LAND AT BIRD IN EYE FARM, UCKFIELD, EAST SUSSEX

TECHNICAL NOTE 1 – HIGHWAYS AND TRANSPORT CONSIDERATIONS

Figure 3.1: Approximate Capacity of Priority Junctions

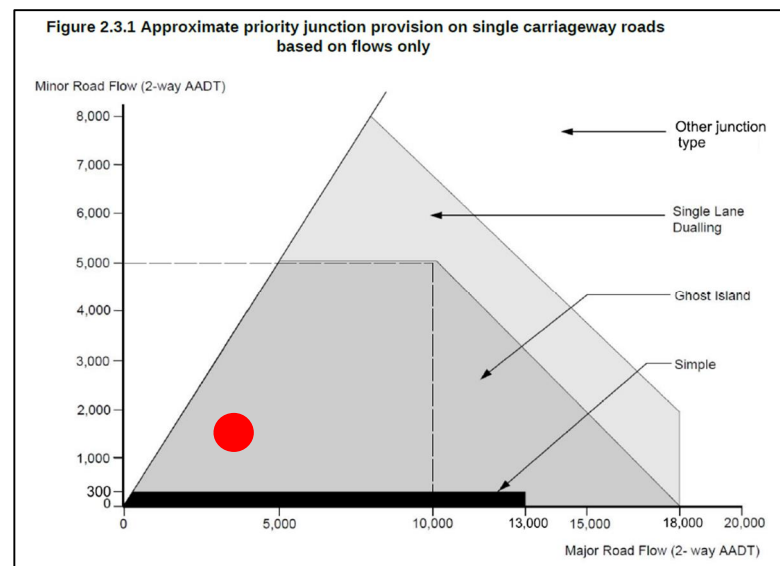
- 3.7 The daily traffic volumes contained in the TA (Table 1) and the likely number of trips generated by the proposed development identified in the TA (Table 7) means that the traffic volumes associated with the proposed access junction lie well outside the typical operational capacity of a simple priority junction as shown by the red dot in **Figure 3.1**.
- 3.8 **Figure 3.1** shows that a ghost island priority junction, i.e. with a separate right turning lane to avoid vehicles waiting to turn right into the site obstructing eastbound through traffic, is required in traffic flow terms and thus supports ESCC's position that such a junction should be provided to access the site.

Figure 3.2: Proposed Traffic Island west of Site Access Junction

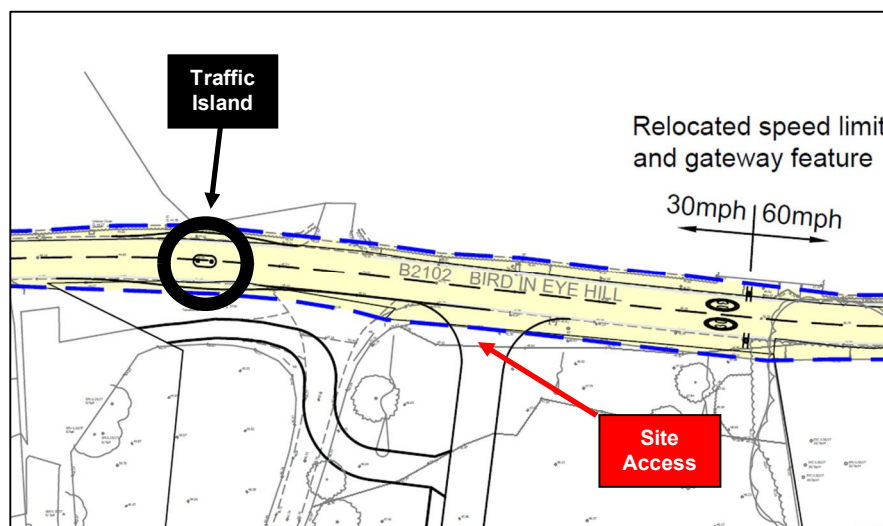
- 3.21 The provision of a traffic island in this location appears to be a contrived measure added simply to enable the visibility to be measured in a way that means that the splay avoids third party land if vehicle speeds remain at present levels and a 30mph speed limit is not introduced via a TRO. **Figure 3.2** below provides an extract of the site access drawing and shows the location of the proposed traffic island and the site access junction.

Figure 3.3: Visibility Splay and Number 18 Bird in Eye Hill

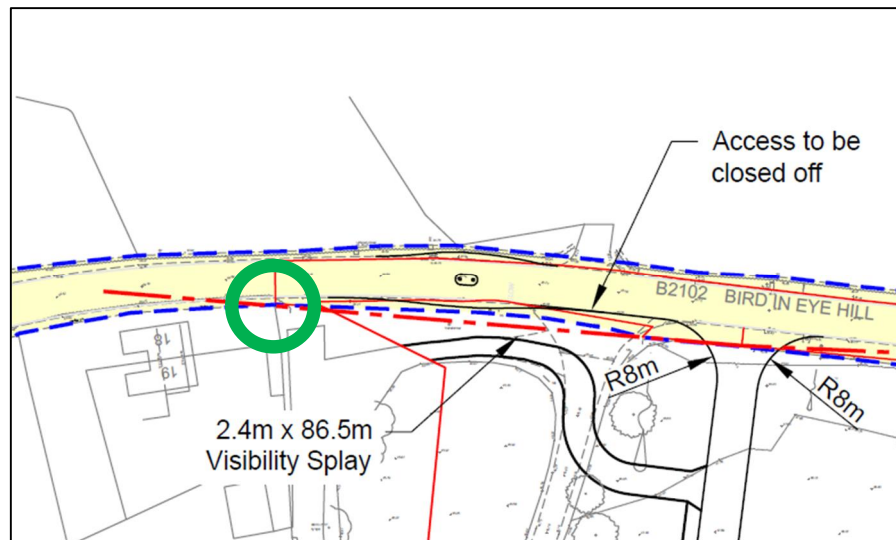
- 3.22 It is important to note that the visibility spay (sight line) to the west just manages to avoid the northeast corner of the garden of number 18 (Bird in Eye Hill) as shown overleaf in **Figure 3.3** by the green circle, which just so happens to be outside the red line/site area. If the visibility splay had been drawn to the nearside kerb, then part of the garden of number 18 would be required to achieve the visibility splay based on the surveyed speeds on this part of the B2102.
- 3.23 Given there are no footways in the vicinity of the proposed traffic island and as there are proposed roundels advising of the 30mph speed either side of the island, it is unclear precisely what function this proposed feature will have other than to enable the visibility splay to be measured in a way that suits the applicant.

Figure 3.4: Visibility Splay and Number 18 Bird in Eye Hill

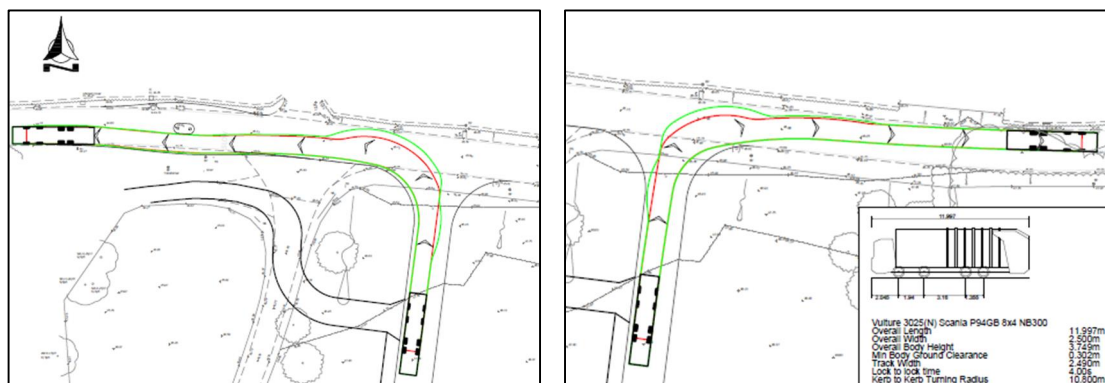
- 3.24 The TA contains swept path analysis showing a refuse vehicle entering and exiting the site via the proposed access junction.
- 3.25 **Figure 3.4** below provides an extract of the exit manoeuvres and shows that the left and right turns out of the site are problematic in that they involve the vehicle encroaching across all of the B2102.

- 3.26 Whilst the TA states in section 5.14 that such vehicles can *conveniently and safely* leave the site in a forward gear, this is questionable based upon the images shown in **Figure 3.4**.

Figure 3.5: Location of Problems identified in RSA at Vehicular Access

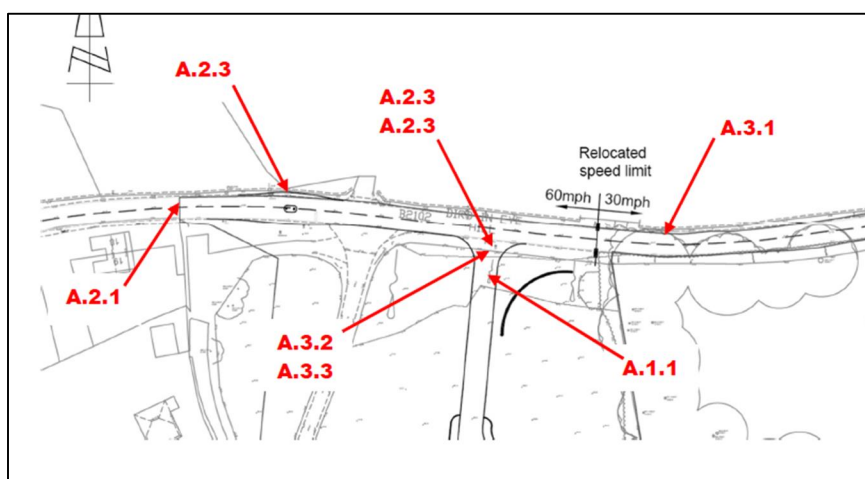
- 3.32 One of these problems (A.2.1) relates to the traffic island discussed above in section 3.21, which enables the visibility to be measured in a way that avoids third party land. An alternative approach to this issue would be to locate the site access junction in a position where it could provide the required visibility (for the surveyed speeds) rather than introduce traffic islands where they do not appear to be needed for any other reasons.

- 3.33 Problem A.3.1 relates to forward visibility between westbound vehicles and vehicles waiting to turn right into the site. The RSA identifies that vegetation within the verge north of the carriageway restricts visibility and, as such, drivers will not have enough warning of right turning vehicles into and from the site. The designer's response refers to the proposed 30mph speed limit (which will need a TRO) but otherwise offers no solution to this issue.

- 3.34 Problem A.3.3 relates to the swept path analysis mentioned in section 3.25 above and the fact that larger vehicles are likely to encroach into opposing lanes (the RSA was written without the benefit of seeing the swept path analysis included in the TA as

Appendix 14). The designer's response states that the swept path analysis shows that these manoeuvres are adequate but this is not accepted as stated in section 3.26 above.

Figure 4.1: Termination of Shared Footway/Cycleway

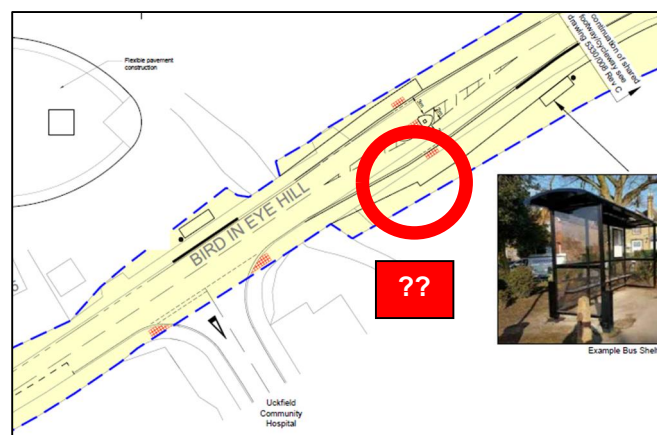
- 4.3 The section of footway along the southern side of Bird in Eye Hill between the pedestrian cycle access and bus stops will be widened to 3m and designated as a shared footway/cycleway. However, it is unclear what happens to cyclists when the shared footway/cycleway terminates at the westbound bus stop just before the access to Uckfield Community Hospital as shown below in **Figure 4.1**.

Figure 5.3: CrashMap Data from the TA

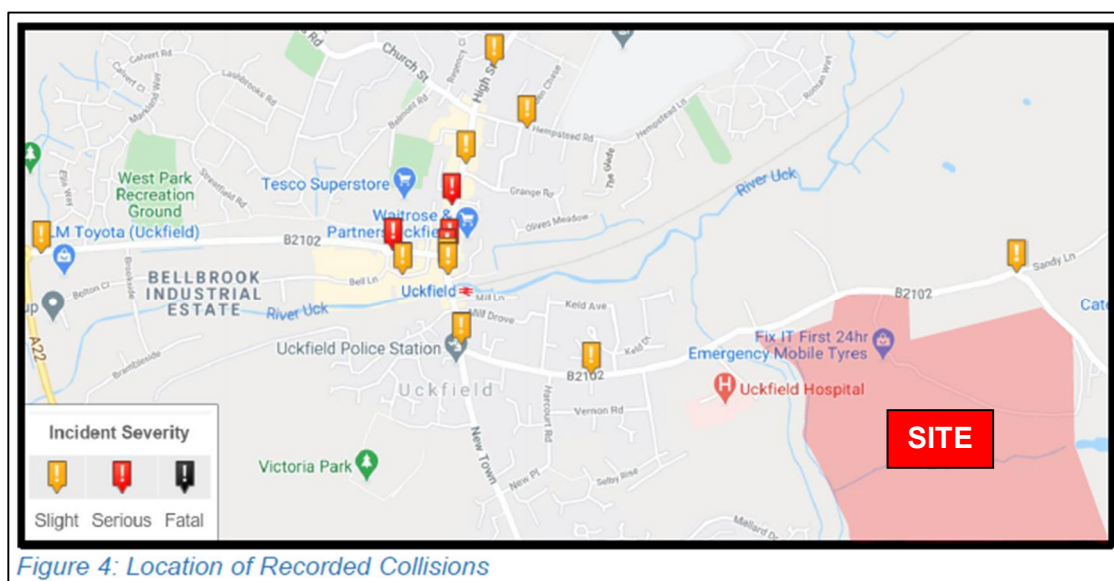
- 5.23 Personal injury collision data was obtained in the TA for the most recent 3-year period (2018-2020) from the CrashMap website. It is worth noting that a 5-year period is normally selected for such an assessment. The data collected is summarised in Figure 4 in the TA, which is reproduced below as **Figure 5.3**.

- 5.24 This shows that there were no accidents close to the proposed site access (and the existing farm access) and just one accident at the junction of Bird in Eye Hill (the B2102) and Sandy Lane to the east of the site.
- 5.25 However, an interrogation of the CrashMap website identifies that two further accidents occurred in the vicinity of the site as shown overleaf in **Figure 5.4**. The CrashMap reports for these accidents are contained as **Appendix A** of this Technical Note.

Figure 5.4: Additional CrashMap Data

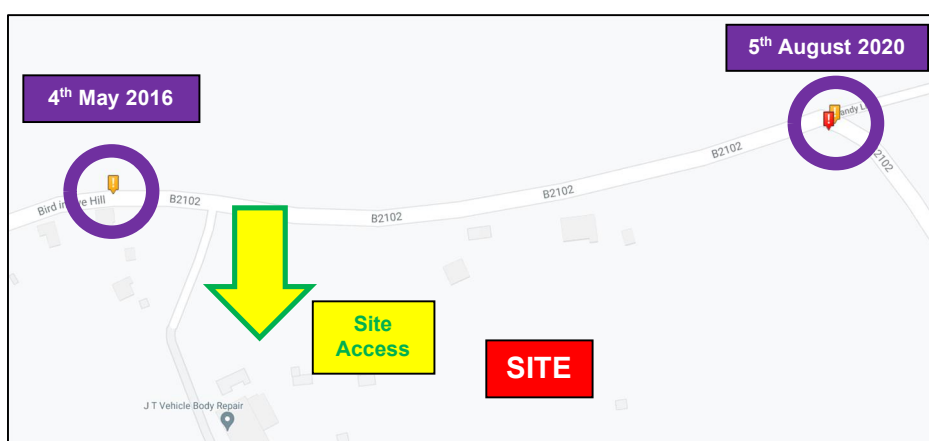
- 5.26 The accident to the west of the site access occurred in 2016 and so would have been identified in the TA if a 5-year period had been selected as is usual. This accident involved a van and a cyclist and resulted in slight injuries being sustained by the cyclist. The location of the accident close to the proposed site access, where forward visibility has been raised as an issue in the RSA, adds to the concerns over the safety of the proposed access junction.

- 5.27 The other additional accident occurred at the junction of Bird in Eye Hill and Sandy Lane to the east of the site. Whilst this accident is likely to have been added to the CrashMap database since the TA was completed, it is important to note its occurrence. This accident involved two cars and resulted in slight and serious injuries being sustained by the occupants of the two cars.

- 5.28 The emergence of these additional accidents suggests that the stretch of the B2102 in the vicinity of the proposed site access junction is not as safe as concluded in the TA and this will be exacerbated by the increase in traffic volumes associated with the proposed development and the provision of a substandard access junction.

Figure 6.1: Footway Widths from Manual for Streets

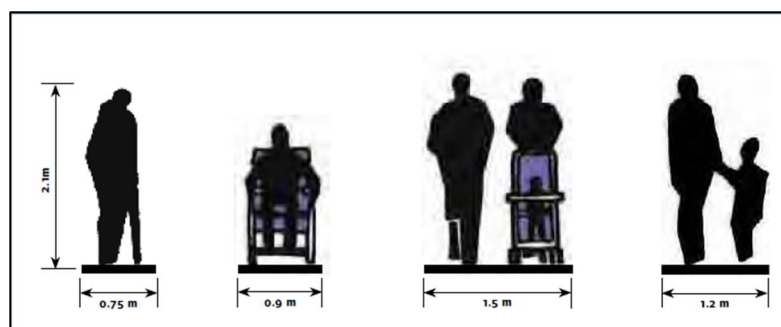
- 6.2 **Figure 6.1** shows that the parts of Framfield Road with a footway width below 1.5m will not allow a buggy and pedestrian to safely pass and so will not encourage future residents to walk to local facilities. Whilst the TA states that pedestrians can cross Framfield Road at this point (and proposes to provide tactile crossing at this location) this is not ideal and will do little to maximise sustainable travel to/from the site.
